Title: Advisory Committee on Reactor Safeguards
Thermal Hydraulics Subcommittee

Date: Thursday, February 16, 2006

UNITED STATES NUCLEAR REGULATORY COMMISSION'S
ADVISORY COMMITTEE ON REACTOR SAFEGUARDS

Surrogate Valve Design

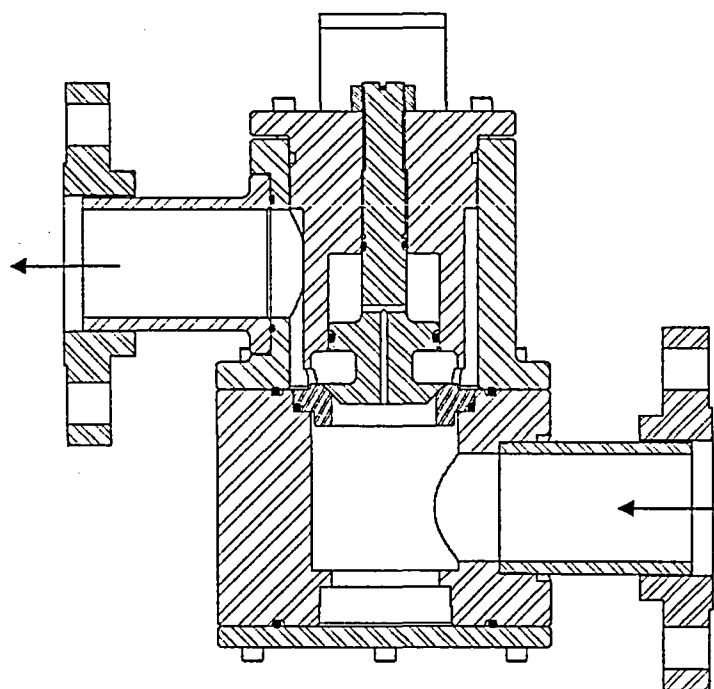
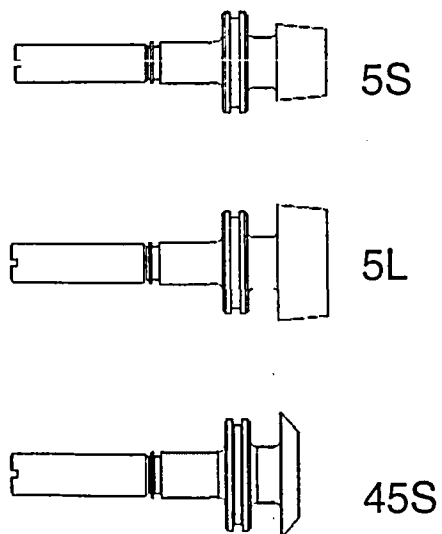
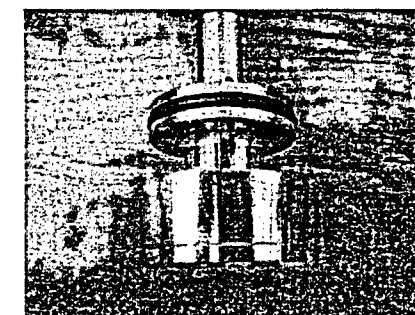
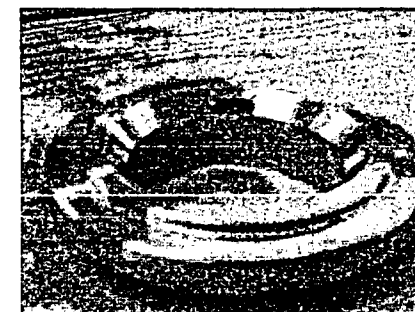
19 There is a typographical error, you want
20 to change this annotation to 45 large at the bottom,
21 and it simply means that the diameter of the two large
22 stems are identical, but the angles are not.

3 DR. KRESS: Yes, on the outlet side, on
4 Figure 2, the annulus.

Alternate Flow Path

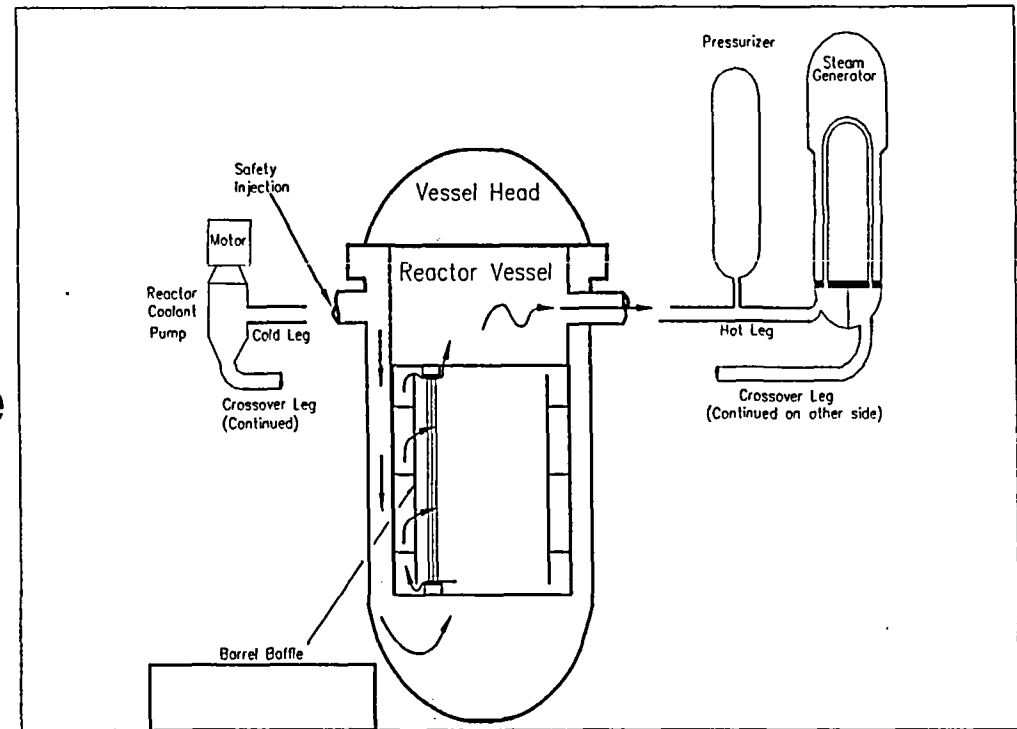
22 CHAIRMAN WALLIS: You are showing me a
23 figure, and you are saying that's probably what
24 happens, but I don't see any kind of code calculation
25 of what happens.

1 debris screens on the bottom of the fuel, okay, to try
2 to catch debris during normal operation to avoid
3 having it come up into the core region? If you
4 already have these other inch and a half holes all
5 over the place that provide lots of bypass flow into
6 the core region, why do you need debris screens on the
7 bottom of the fuel bundles?

12 DR. BANERJEE: I guess Ralph's question
13 is, if you get this cross flow, and it brings debris
14 in, it will just deposit it in an outer ring, and the
15 inner fuel --

10 And, the reason the holes are there is to
11 provide, during an upset condition where you
12 depressurize the reactor quickly, pressure release
13 yield implode or explode the baffle barrel region.
14 You know, it's not a main flow path under normal
15 operating conditions.
